P02	23.01.25 Amendments as per most recent AT Design Workshop...	MB	PK
Rev.	Date	Description	Drawn Approved

Project **Active Travel Fund
Ryhope Road Cycle Route**

Subject **Consultation Plan
Sheet 5**

Drawing No. **ATRR-SCC-GEN-Z0-SK-Z-SK_023-S4** Revisions **P02**

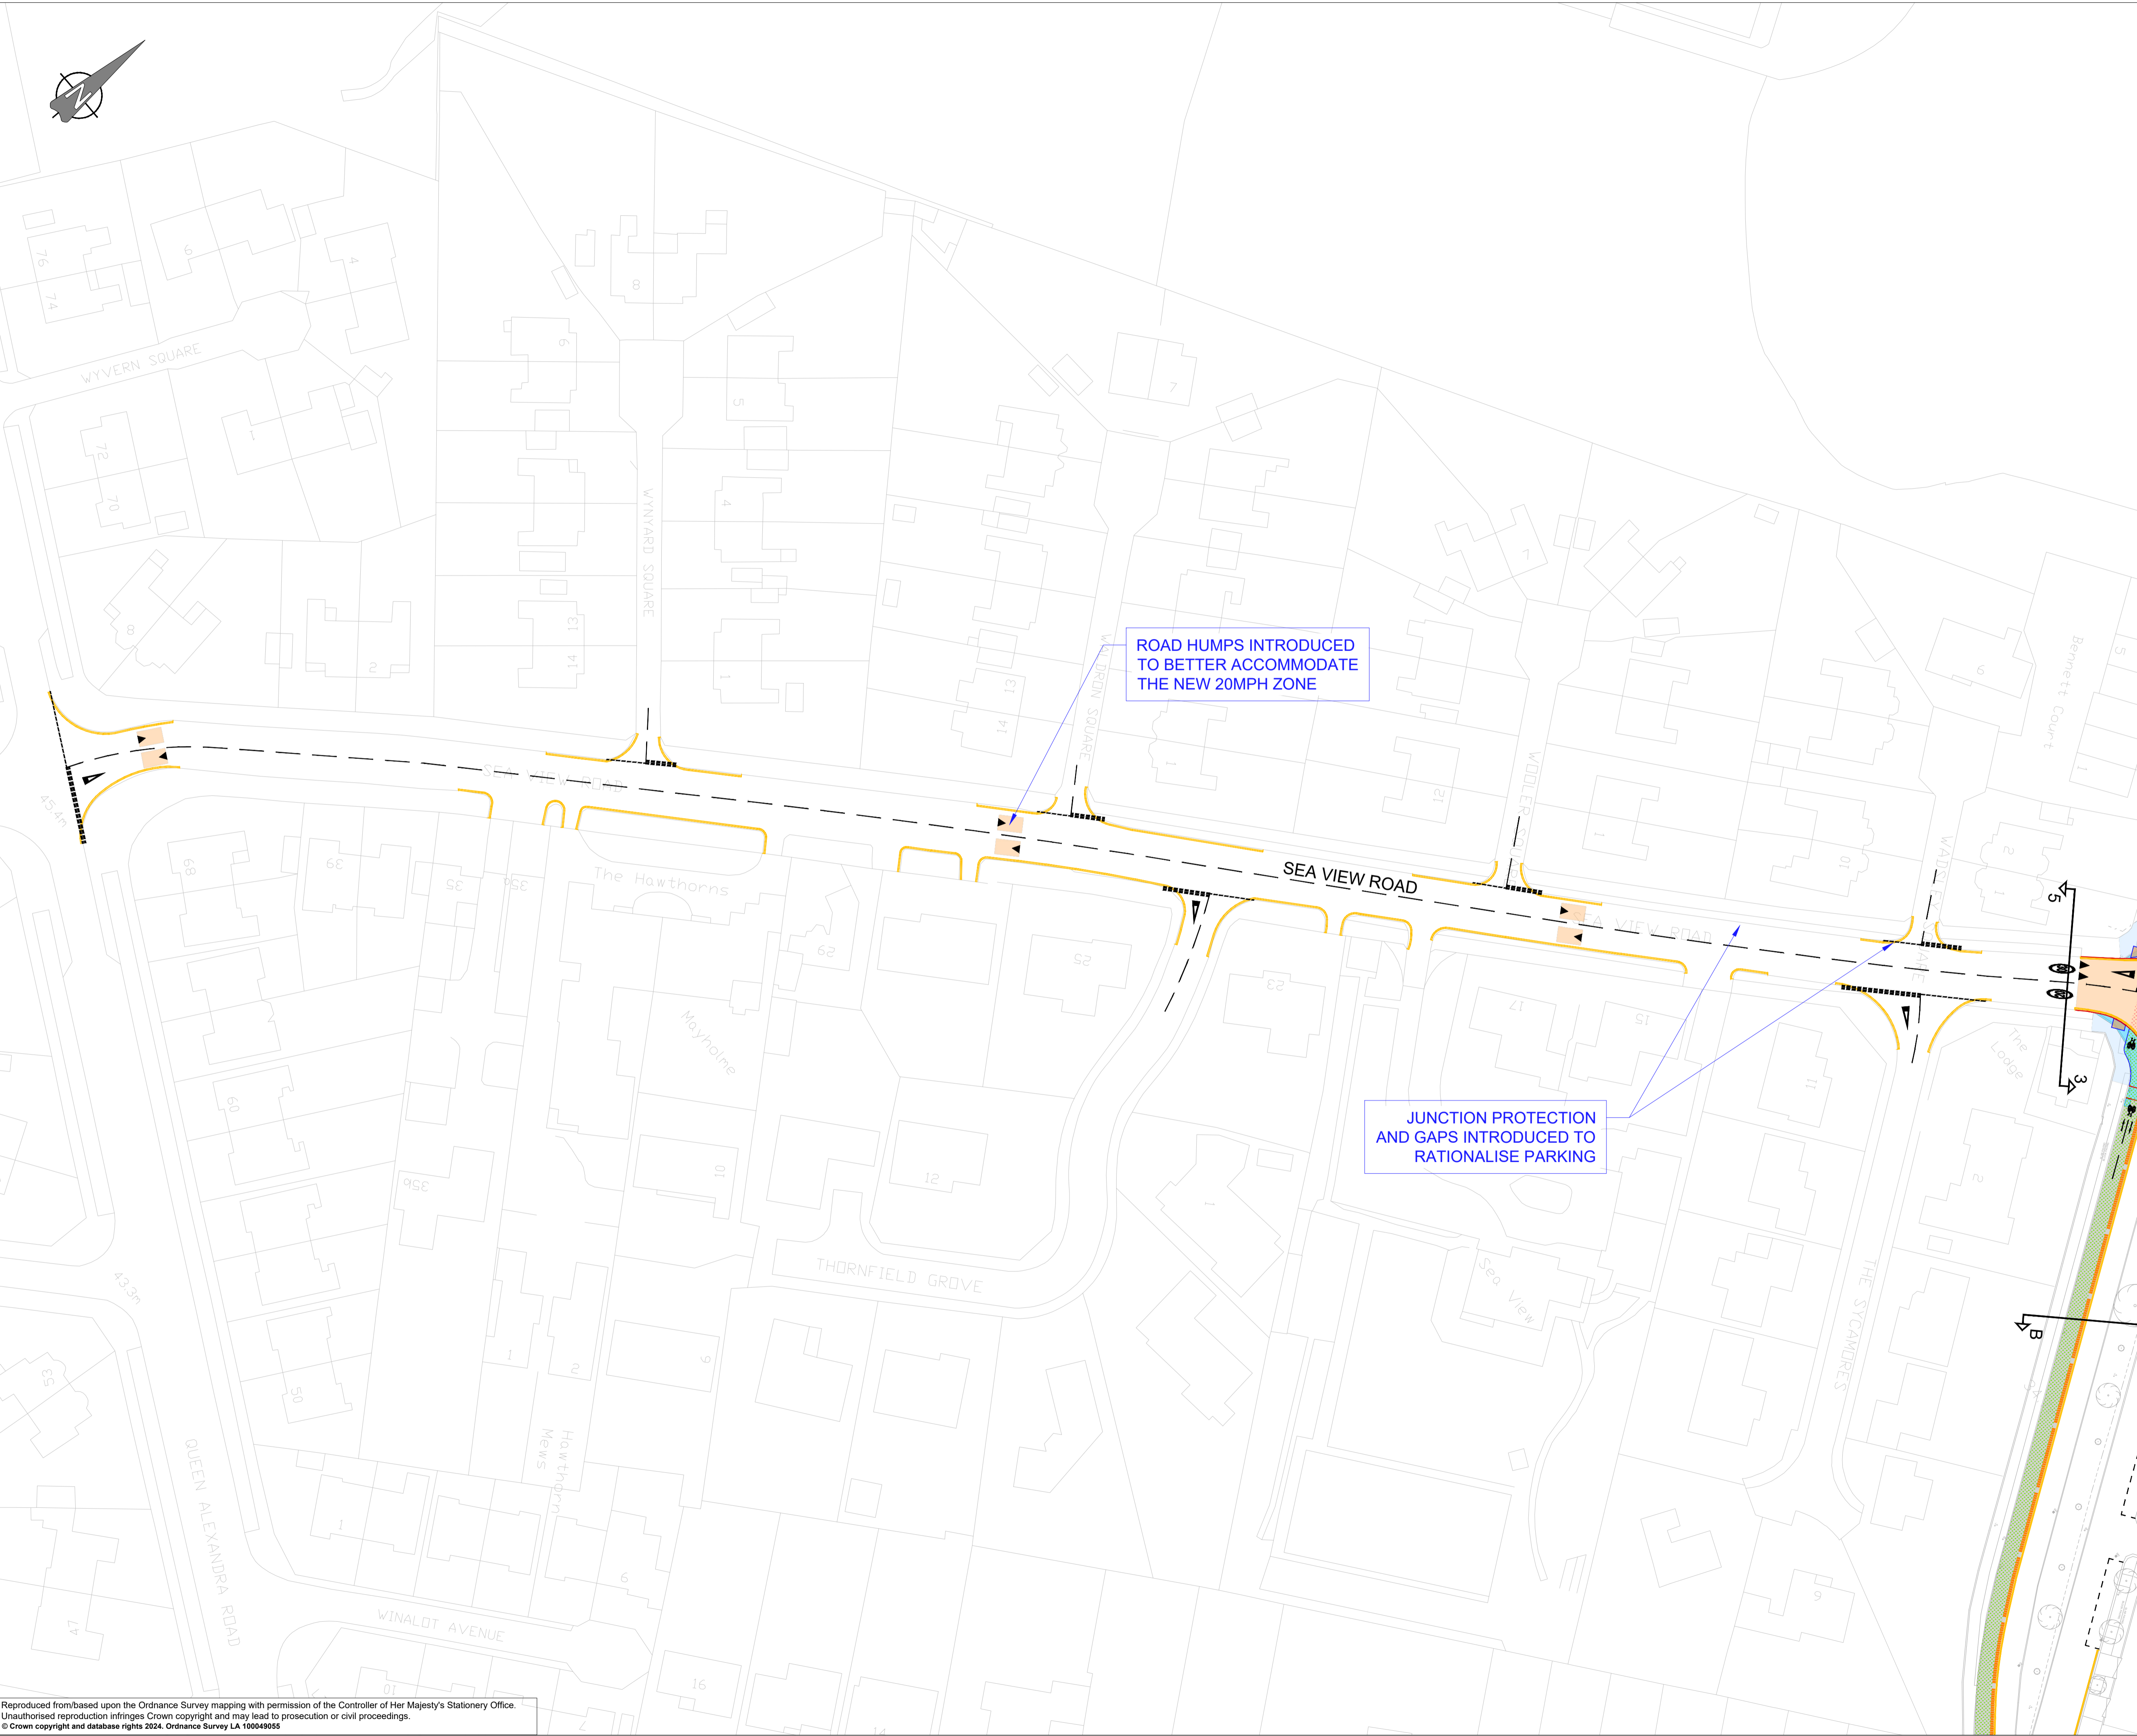
- PRINCIPAL CHANGES**
1. ONLY BUS STOPS ILLUSTRATED TO BE AMENDED OR UPGRADED. ALL OTHER EXISTING BUS INFRASTRUCTURE TO BE RETAINED AS IS.
 2. RYHOPE ROAD DUAL-CARRIAGEWAY EXTENTS REDUCED TO SINGLE LANE IN BOTH DIRECTIONS TO ACCOMMODATE PARALLEL PARKING AND SEGREGATED CYCLE LANES.
 3. PROPOSED TRAFFIC SIGNING AND SIGNALS OMITTED FROM DRAWINGS FOR CLARITY - SUITABLE LAYOUT TO BE DEVELOPED IN THE DESIGN STAGES.

ROAD HUMPS INTRODUCED TO BETTER ACCOMMODATE THE NEW 20MPH ZONE

JUNCTION PROTECTION AND GAPS INTRODUCED TO RATIONALISE PARKING
